ADDENDUM NO. 2

OWNER: Lower San Joaquin Levee District

PROJECT: FSRP Critical Erosion Repair Project

DWR_NA0010_06_LM0.05L
EROSION SITE 1 - PLAN

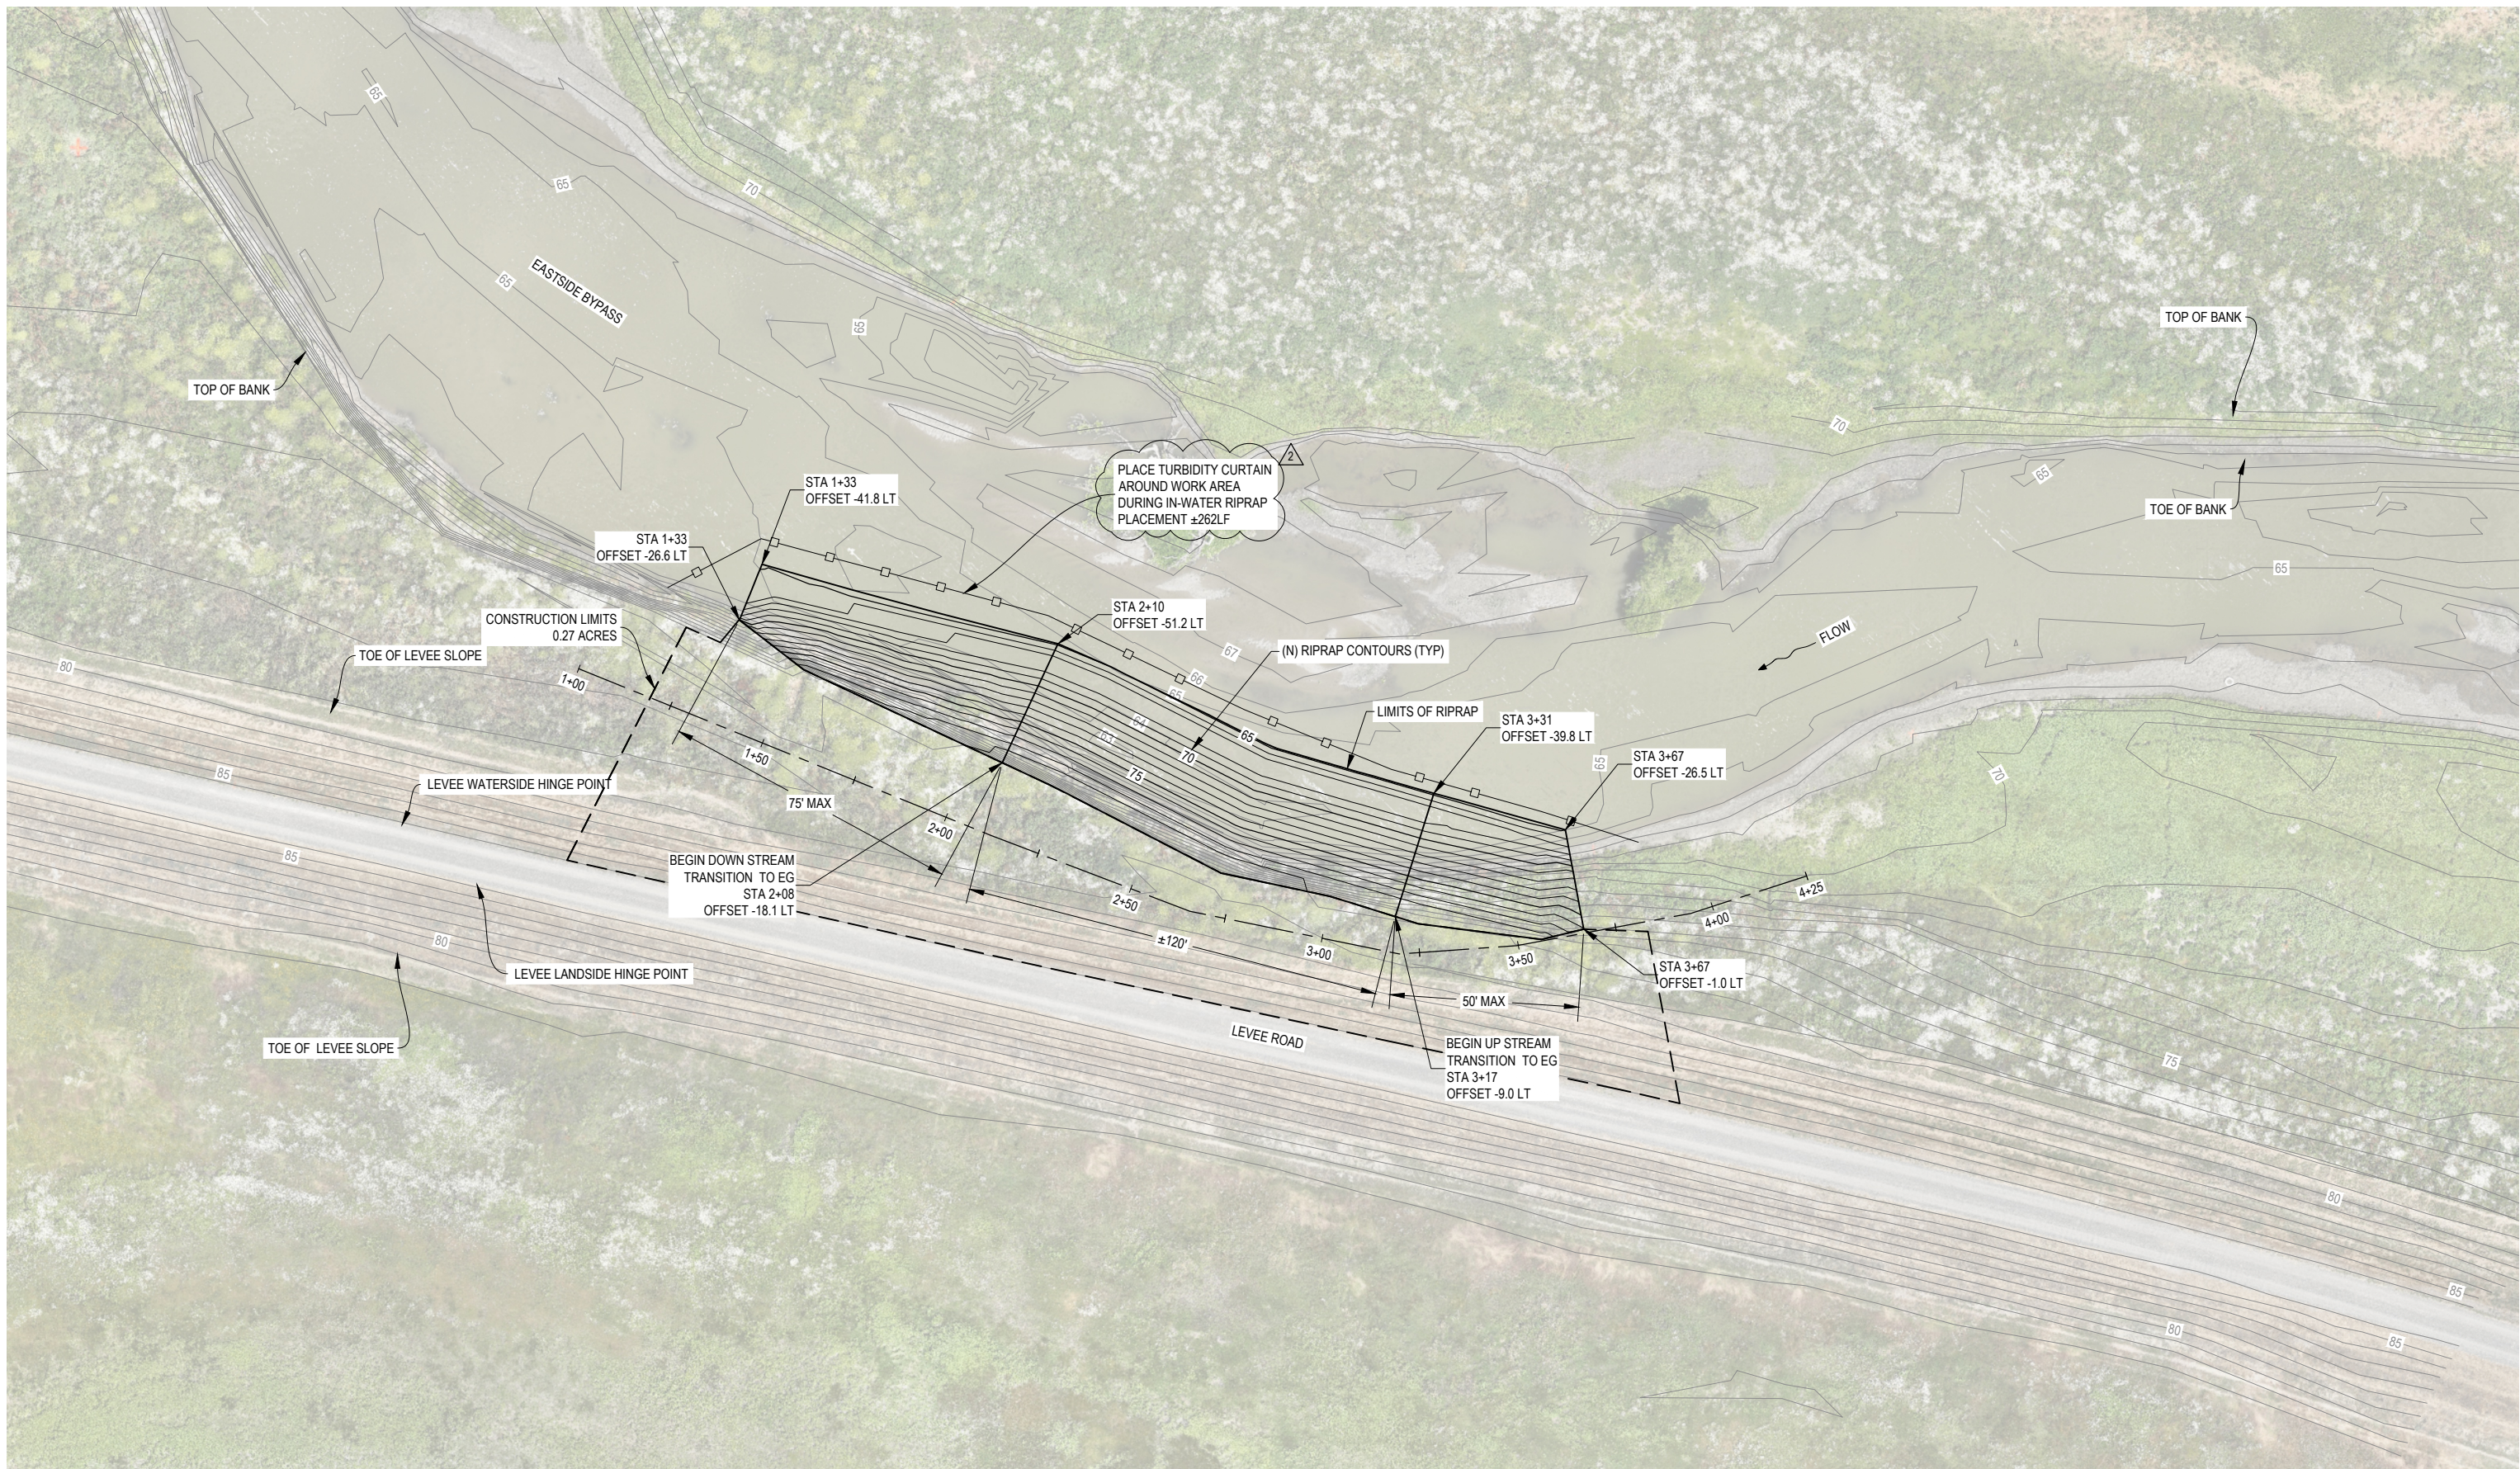
- Q4. It was discussed at the prebid meeting that the current layout showing the turbidity curtain only at the downstream section may change to include**

downstream and upstream due to the minimal flow of water / potential windy conditions. Please advise.

- **C-101 – Base Map & Haul Route:** Revised haul routes.
- **CS101 – Erosion Site 1 Plan:** Revised turbidity curtain plan.
- **CS102 – Erosion Site 2 Plan:** Revised turbidity curtain plan.
- **CS103 – Erosion Site 3 Plan:** Revised turbidity curtain plan.

- A4. The Contract Drawings have been revised to show the turbidity curtain layout based on anticipated site conditions. See the revised plan sheets included with this Addendum.

LOWER SAN JOAQUIN LEVEE DISTRICT CRITICAL EROSION REPAIR PROJECT NA0010, UNIT 6		DATE MAY 2026
DWR_NA0010_06_LM2.56L EROSION SITE 2 - PLAN		SHEET IDENTIFICATION CS102 SHEET 7 OF 12 KSN PROJECT FILE NO. 2495-0020

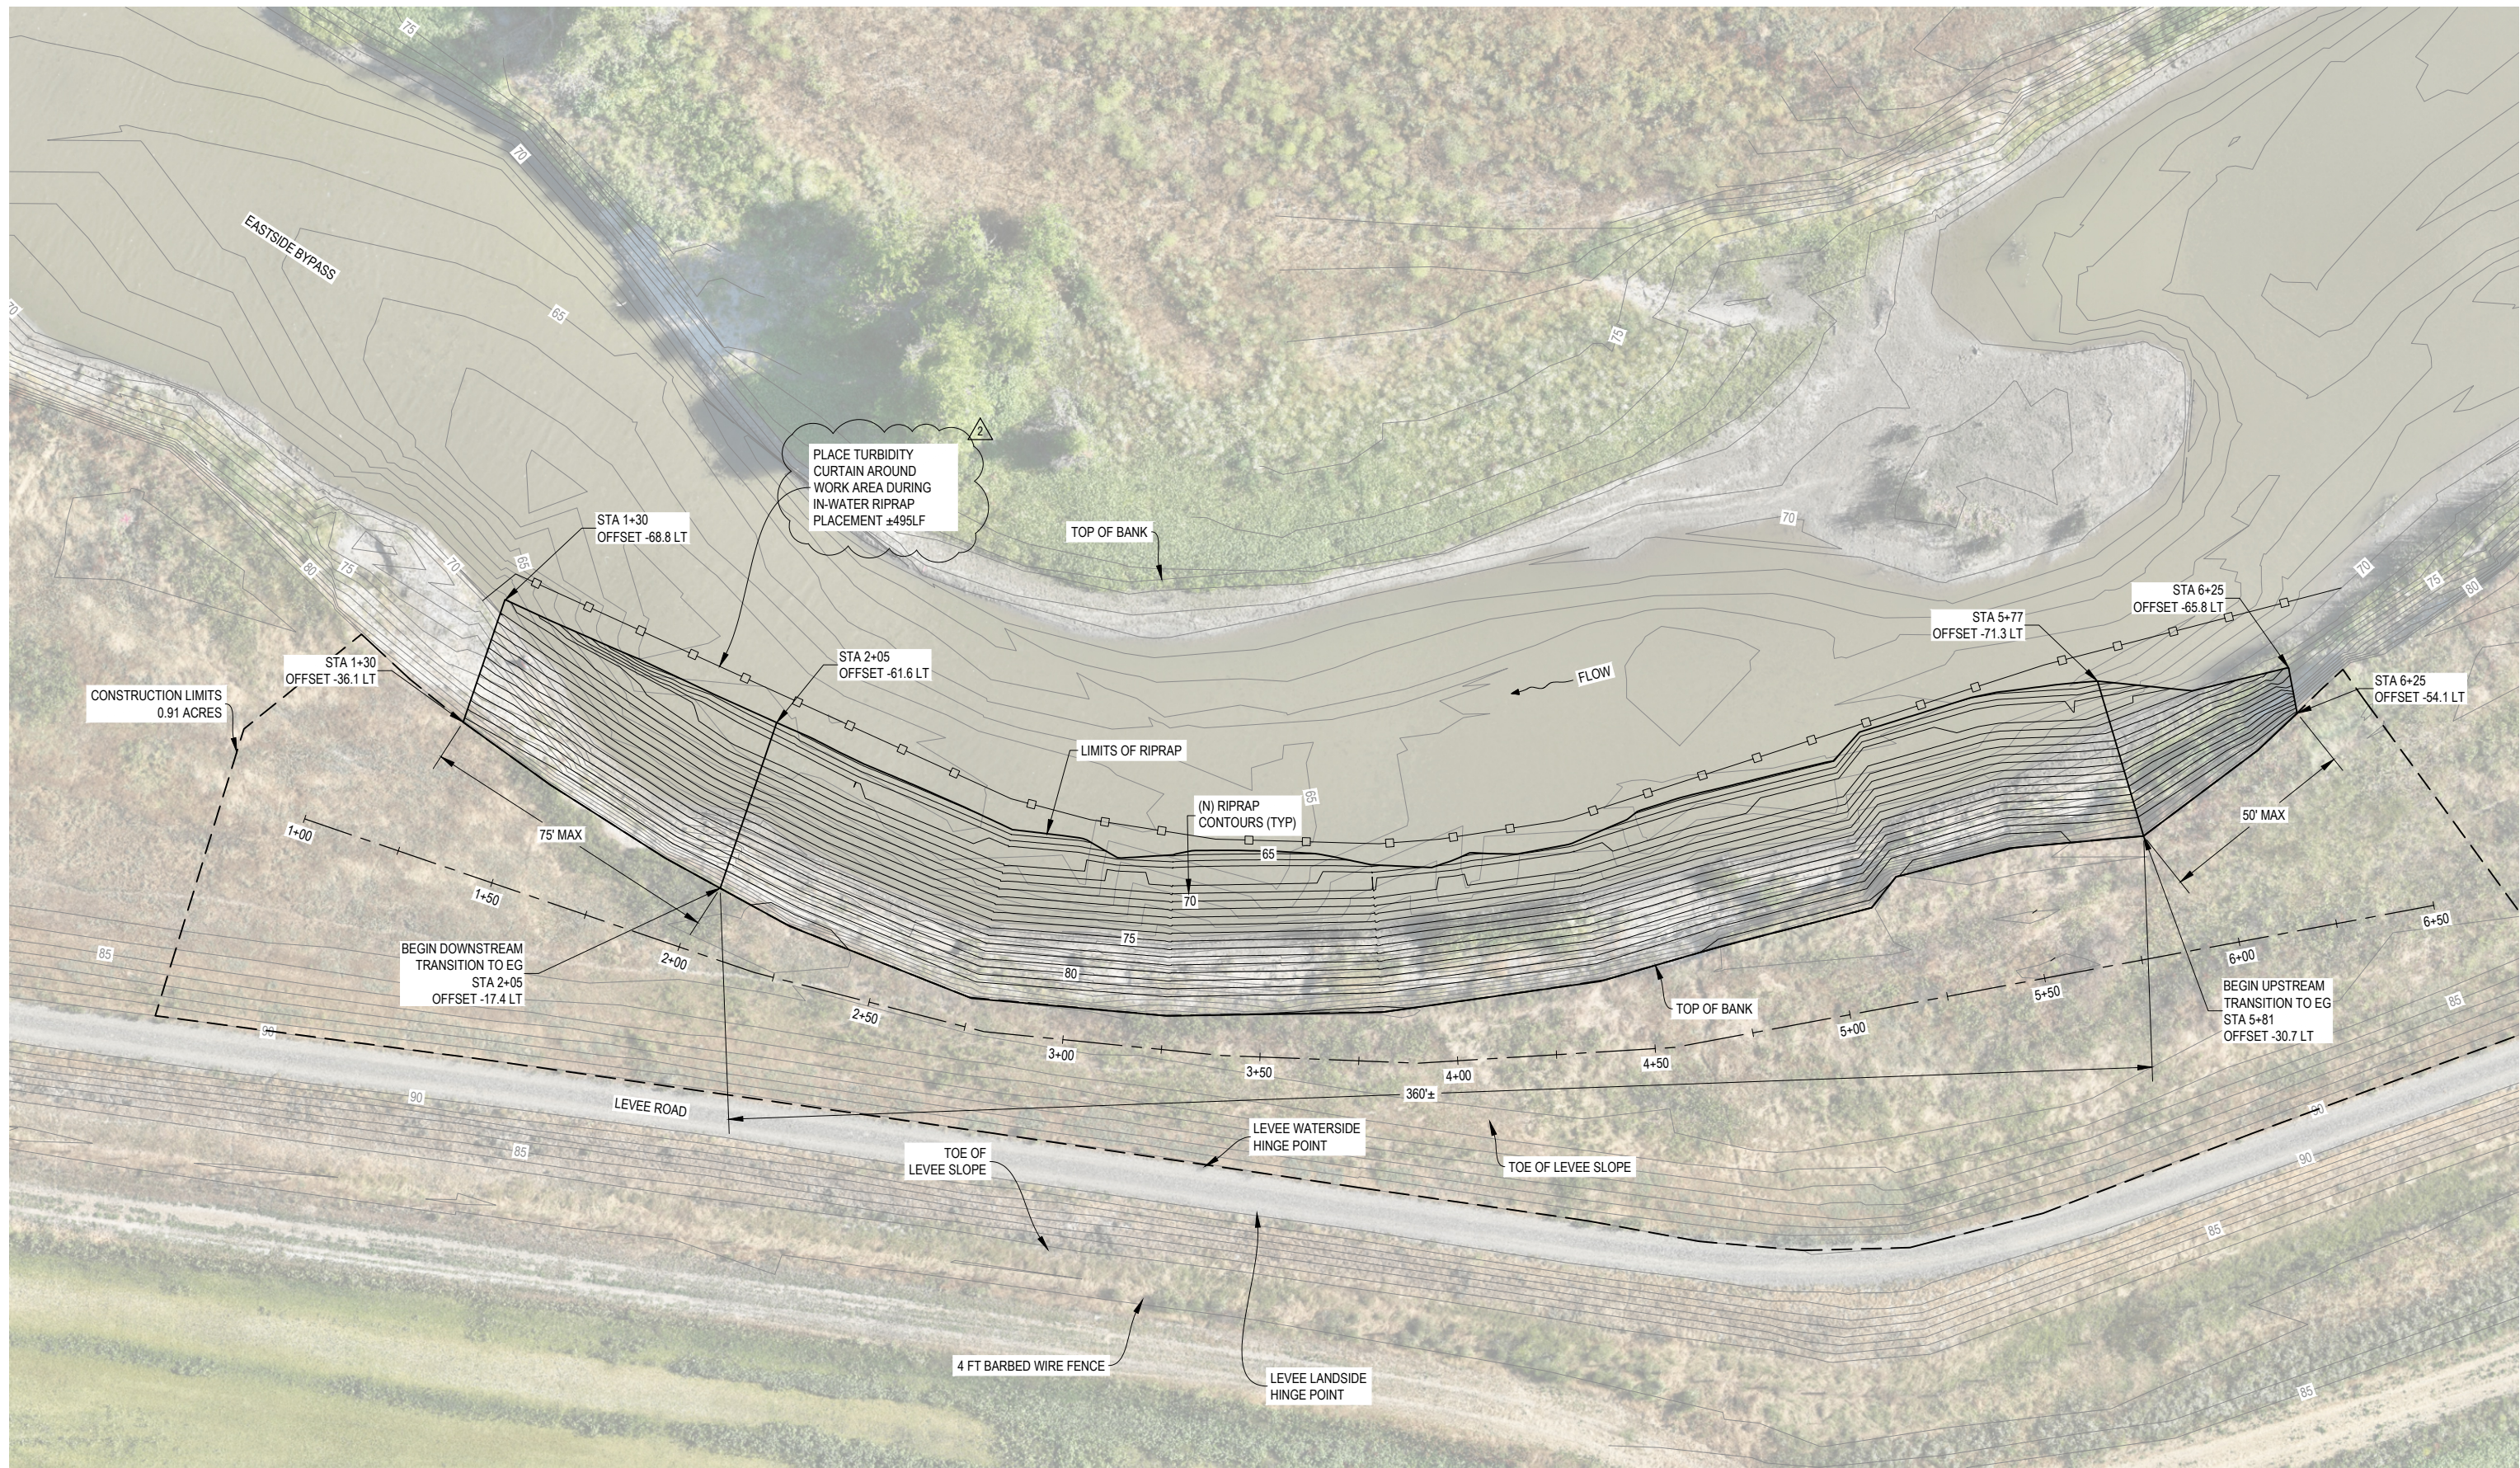
- Q10. Can you also provide further clarification on the approved haul routes / turn around areas? Sites 2 and 3 did not appear to have large turn around areas for heavy trucks. If optional routes are available please provide updated routes.**

- A10. The Contract Drawings have been revised to identify haul routes. See revised plan sheets included with this Addendum.
